Addendum 57 – UN Regulation No. 58

Revision 3 - Amendment 2

Supplement 2 to the 03 series of amendments – Date of entry into force: 25 September 2020

Uniform provisions concerning the approval of:

Figure 1

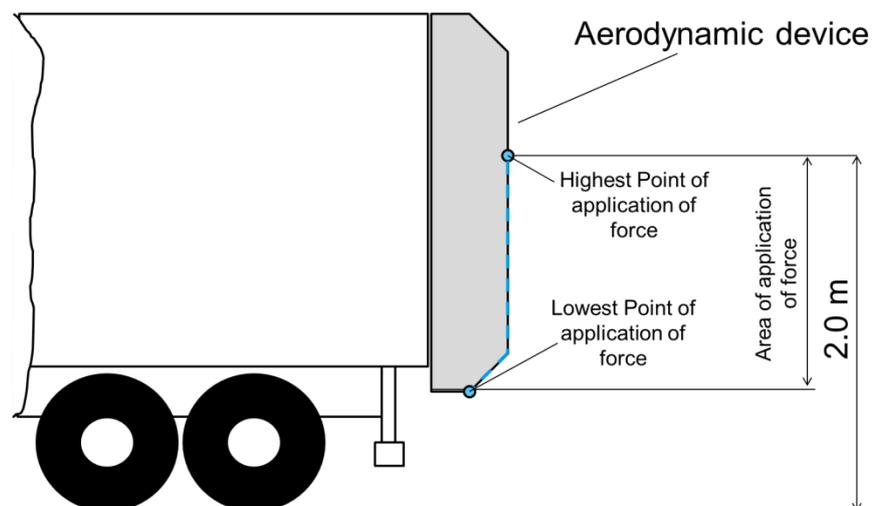
- 5.1.1. A force shall be applied parallel to the longitudinal axis of the vehicle via a surface not more than 250 mm in height and 200 mm wide with a radius of curvature of 5 ± 1 mm at the vertical edges or an adaptor. The surface or adaptor shall not be rigidly fixed to the aerodynamic device and shall be articulated in all directions. When the test is carried out on a vehicle the height of the centre of the surface or adaptor shall be defined by the manufacturer in an area between the lowest edge of the aerodynamic device and a point no more than 2.0 meters above the ground in vehicle-mounted condition (see figure 1). This point is to be defined on a laden vehicle with the technically permissible maximum laden mass.

Figure 2

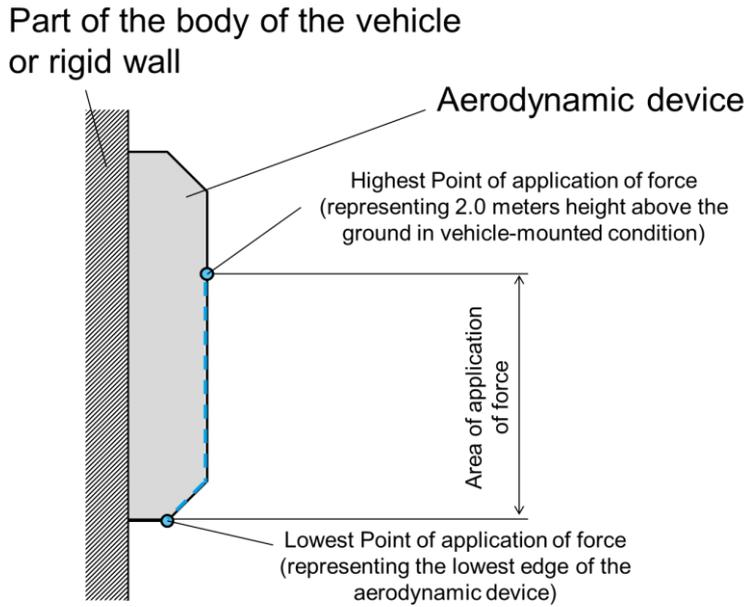
When the test is carried out on a part of the body of the vehicle type or on a rigid wall the height of the centre of the surface or adaptor shall be defined by the manufacturer in an area between the lowest edge of the aerodynamic device and the point that represents the height of no more than 2.0 meters above the ground in vehicle-mounted condition on a laden vehicle with the technically permissible maximum laden mass (see figure 2).

Figure 3

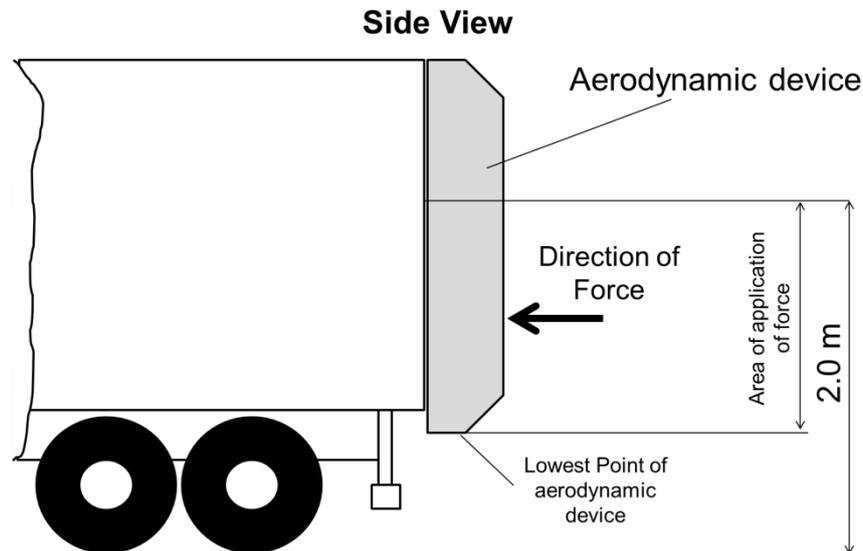
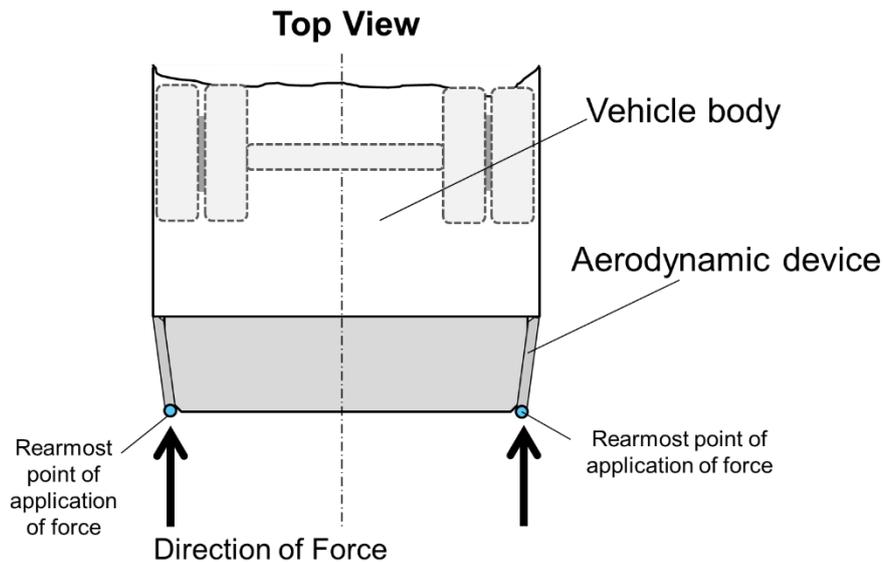
5.1.2. A horizontal force of maximum $4000 \text{ N} \pm 400 \text{ N}$ shall be applied consecutively to two points situated symmetrically about the centre line of the vehicle or the centre line of the device on the rearmost outer edge of the aerodynamic device in completely unfolded or not retracted condition (see figure 3). The order in which the forces are applied may be specified by the manufacturer.

Figure 4

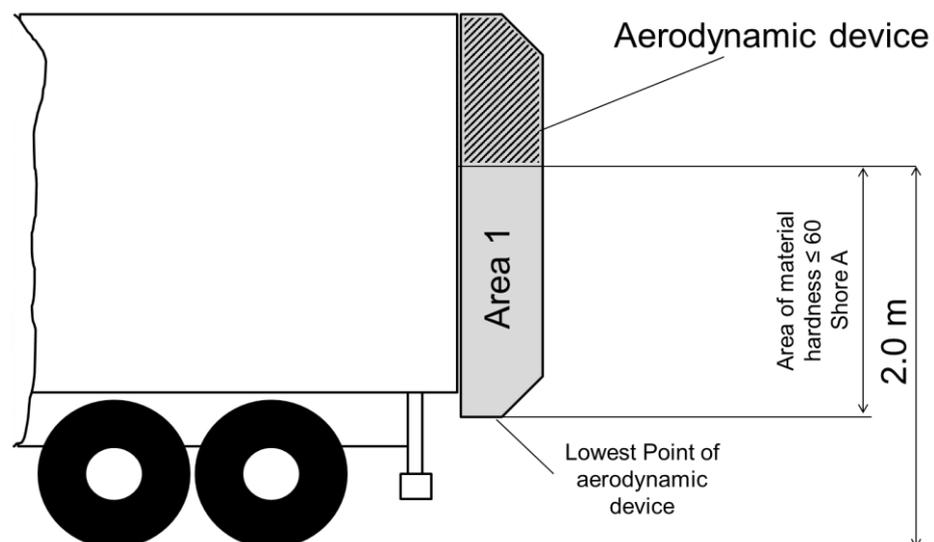
- 6.2. Notwithstanding the provisions in paragraph 5.1., 5.1.1., 5.1.2. and 6.1. the application of forces shall not be conducted if the aerodynamic device is made of a material of hardness not exceeding 60 shore A in the area 1 regarding figure 4. Components (fastenings, hinges, actuators, springs, cables, lamps, etc.) used to install the aerodynamic device on the body of the vehicle or that are mounted on the aerodynamic device are exempted from these provisions.
